Site Survey of Selected Items
for
Compliance with the Americans with Disabilities Act
(ADAAG)
and
Title 24 of the CBC

The site survey of William Howard Taft High School was conducted on February 26, 2007 during a spot check for compliance with the Americans with Disabilities Act Guidelines (ADAAG) and Title 24 of the CBC

Facility Name: William Howard Taft High School

Boys Restroom Building M

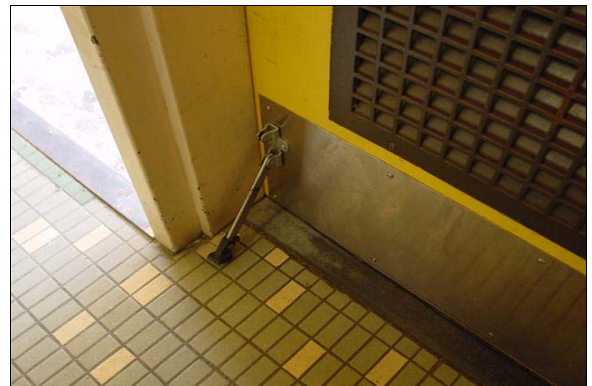
Finding: There is signage indicating accessibility on the entry door to the restroom. The signage is centered 60 inches above the floor on the latch side of the entrance door and includes Braille and raised lettering, gender use symbol and the ISA symbol.

Full Rec The restroom is designated accessible and should be made an accessible restroom for the facility. Monitor signage for continued compliance with CBC 1115B.5, ADAAG 4.1.2(7) and ADAAG 4.1.6(3)(e) and ADAAG 4.30.
